Addendum No. 01
ID 4570-12-71/72
Revised Sheet 144
March 6, 2019

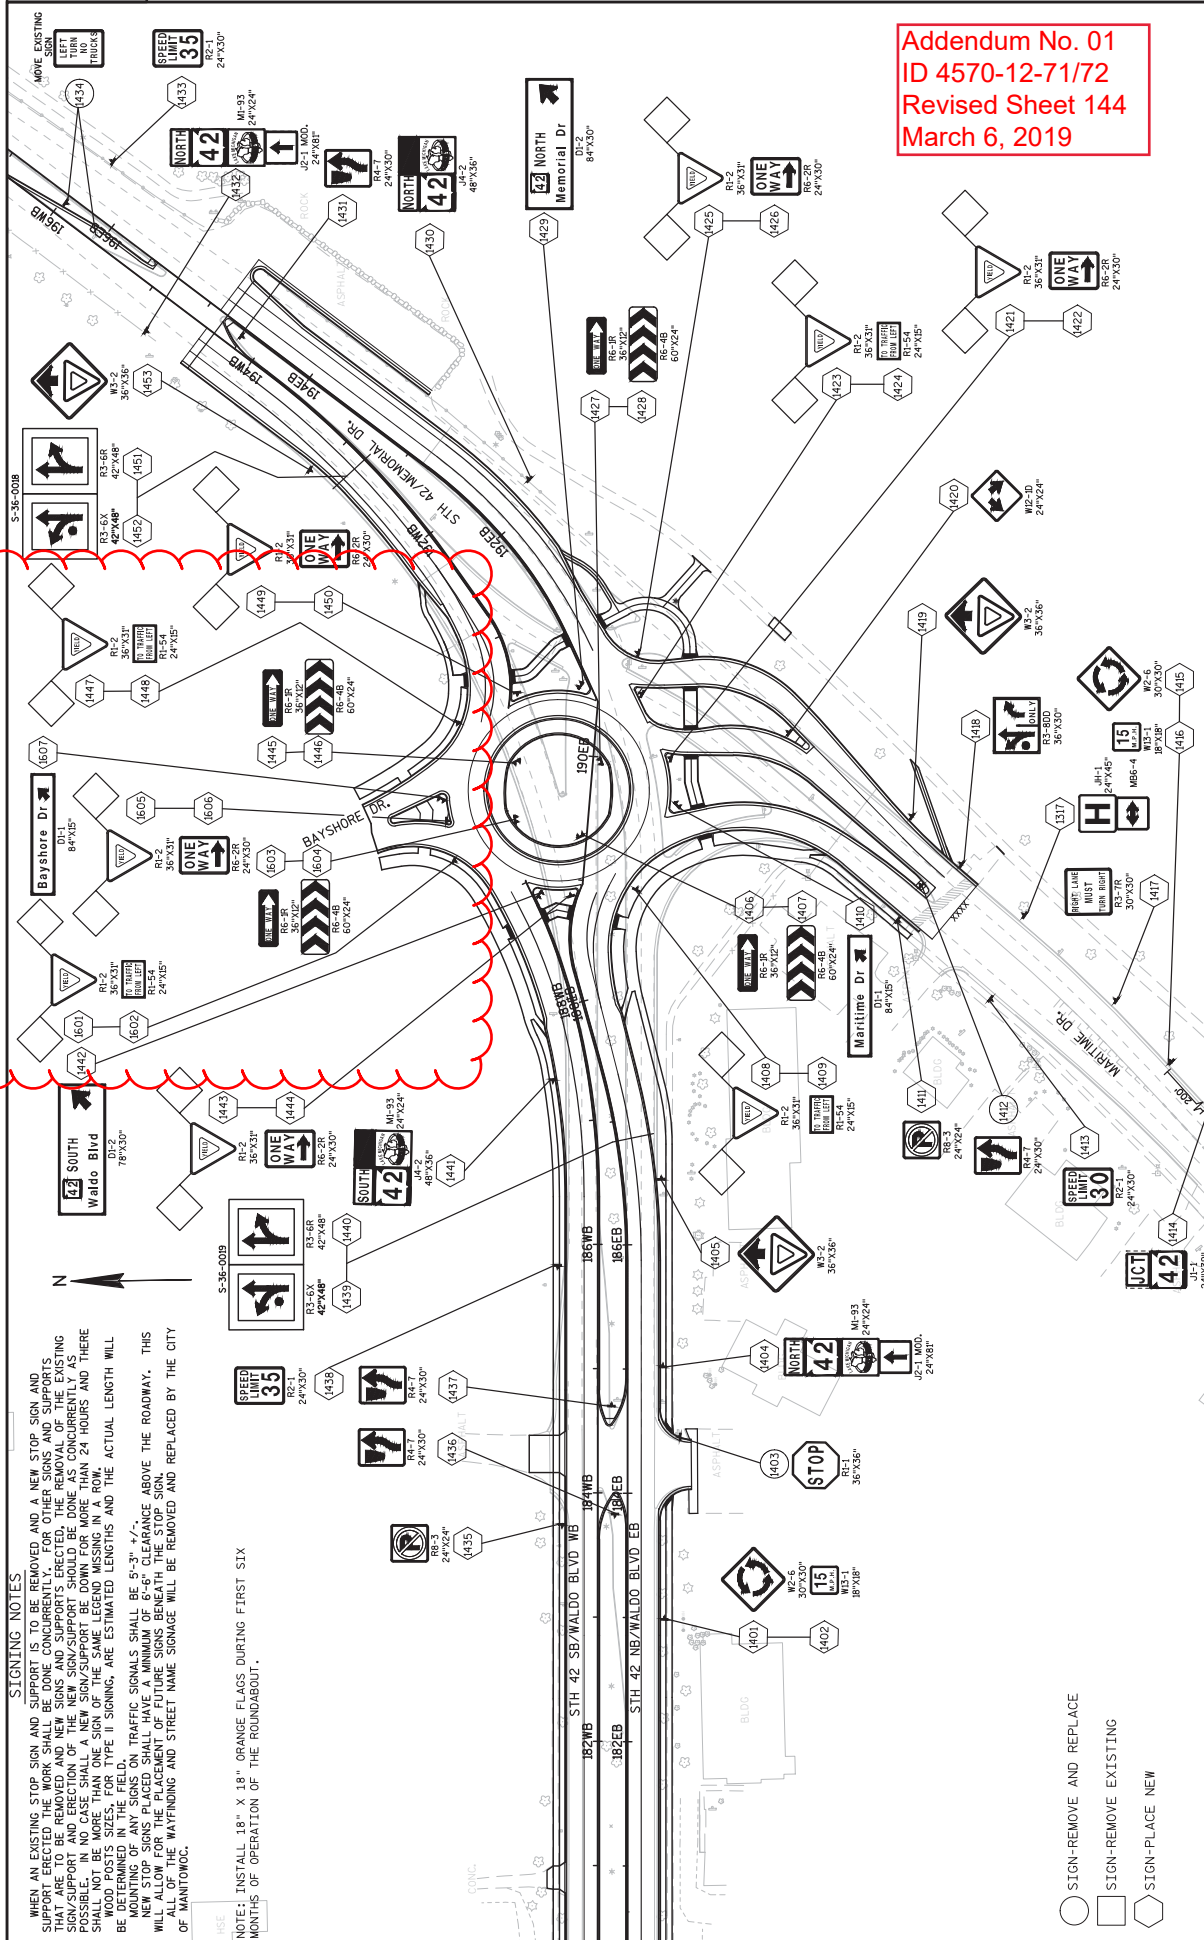
WHEN AN EXISTING STOP SIGN AND SUPPORT IS TO BE REMOVED AND A NEW STOP SIGN AND SUPPORT ERECTED THE WORK SHALL BE DONE CONCURRENTLY. FOR OTHER SIGNS AND SUPPORTS THAT ARE TO BE REMOVED AND NEW SIGNS AND SUPPORTS ERECTED, THE REMOVAL OF THE EXISTING SIGNS AND SUPPORTS SHALL BE DONE FIRST. THE REMOVAL OF THE EXISTING SIGNS AND SUPPORTS SHALL BE DONE FIRST. IN NO CASE SHALL A NEW SIGN/SUPPORT BE DONE FOR MORE THAN 24 HOURS AND THERE SHALL NOT BE MORE THAN ONE SIGN OF THE SAME LEGEND MISSING IN A ROW. ROAD POSTS SIZE 300 FOR TYPE 1 SIGNING, ARE ESTIMATED LENGTHS AND THE ACTUAL LENGTH WILL BE DETERMINED BY THE NUMBER OF SIGNS TO BE MOUNTED ON SIGNS ON TRAFFIC SIGNALS SHALL BE 5'-3" $\pm$ 1/2".

NEW STOP SIGNS PLACED SHALL HAVE A MINIMUM OF 6'-6" CLEARANCE ABOVE THE ROADWAY. THIS WILL ALLOW FOR THE PLACEMENT OF FUTURE SIGNS. WHEREAS THE EXISTING SIGN IS TO BE REMOVED AND REPLACED BY THE CITY OF MANTOWOC, THE EXISTING SIGN AND SUPPORT SHALL BE REMOVED AND REPLACED BY THE CITY OF MANTOWOC.

NOTE: INSTALL 18" X 18" ORANGE FLAGS DURING FIRST SIX MONTHS OF OPERATION OF THE ROUNDABOUT.
